**Unconfirmed Minutes  
IEEE 802.3 CSMA/CD PLENARY  
Kauai, HI  
November 11 -15, 2002**

**Interpretation Number:** 2-11/02 (10 & 100Mb/s Carrier Detect)  
**Topic:** 10Mb/s and 100Mb/s Carrier Detect  
**Relevant Clause:** Figure 7-6 and Figure 24-14.  
**Classification:**

Figure 7-6 – PLS Input and Data\_Valid function

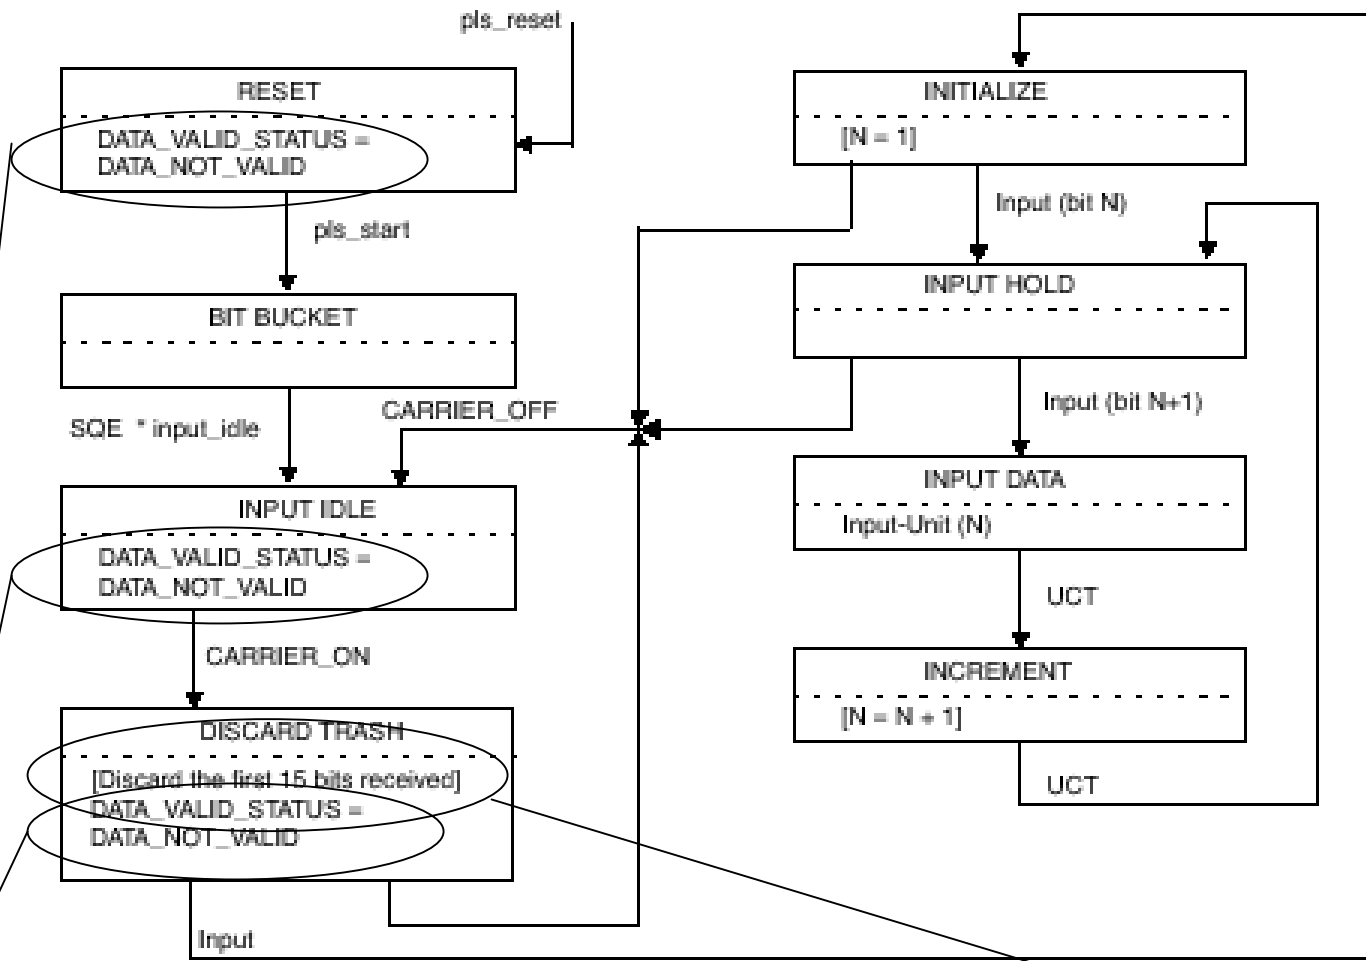
Specific subsection: Figure 7-6 -PLS Input and Data\_Valid function

In the above mentioned figure,

1. In most of the states `DATA_VALID_STATUS` takes value `DATA_NOT_VALID` only and no where it takes `DATA_VALID` value. Please clarify in which states it has to be assigned to `DATA_NOT_VALID` and in which states `DATA_VALID` value.
2. In `DISCARD TRASH` state the action mentioned is to " Discard the first 15 bits received ". Is this 15 bits corresponds to Preamble bits?? How MAC will interpret about this discarding. Please clarify why it is so?

The standard clearly states in subclause 7.2.2.1.6 DATA\_VALID\_STATUS ‘The PLS sublayer sends the MAC sublayer DATA\_VALID\_STATUS whenever the PLS sublayer detects a change in receive data status. The PLS sublayer sends DATA\_VALID when it receives an *input* message from the PMA and the previous DATA\_VALID\_STATUS that the PLS sublayer sent to the MAC sublayer was DATA\_NOT\_VALID. The PLS sublayer sends DATA\_NOT\_VALID when it is not receiving an input message from the PMA and the previous DATA\_VALID\_STATUS that the PLS sublayer sent to the MAC sublayer was DATA\_VALID.’ This text provides the description of where DATA\_NOT\_VALID takes the DATA\_VALID value.

Figure 24-14—Carrier Detect state diagram

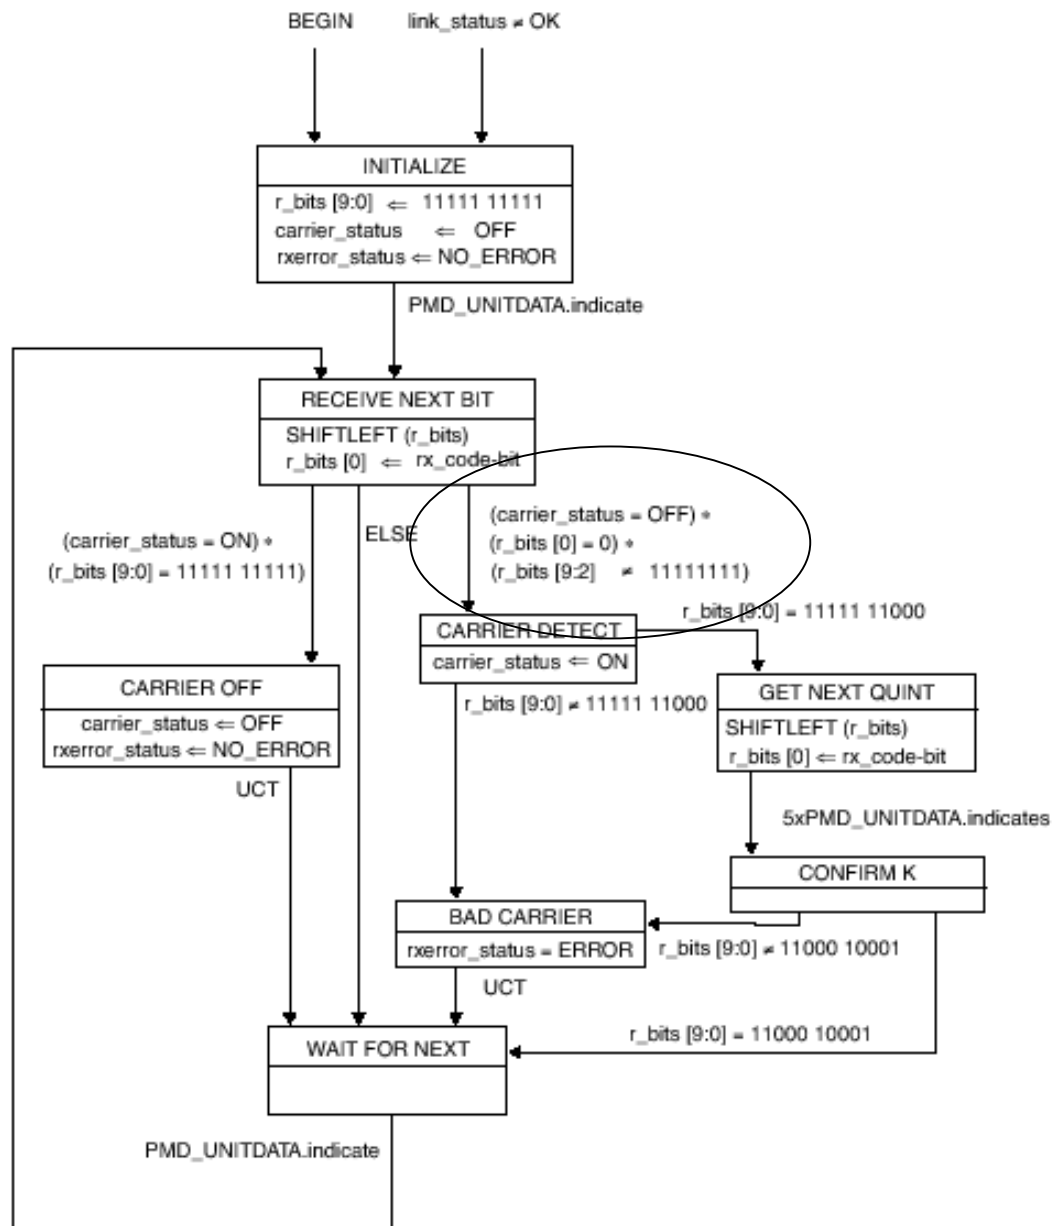
Clause: 24. Physical Coding Sublayer (PCS) and Physical Medium Attachment (PMA) sublayer, type 100BASE-X Specific subsection: Figure 24-14 - Carrier Detect state diagram, Entry condition for CARRIER DETECT state

Bec'z of this condition  $(\text{r\_bits}[9:2] \neq 11111111)$  check, the entry to the CARRIER DETECT state is not possible . In real time the symbol sequence is I-I-I-I-J-K i.e. when the node starts receiving symbol, the condition  $(\text{r\_bits}[9:2] = 11111111)$  only allows the entry to the CARRIER DETECT state.

Among the condition checks for  $\text{r\_bits}[9:2] = "11111111"$ ,  $\text{r\_bits}[9:2] \neq "11111111"$  which one is correct ??? Please clarify.
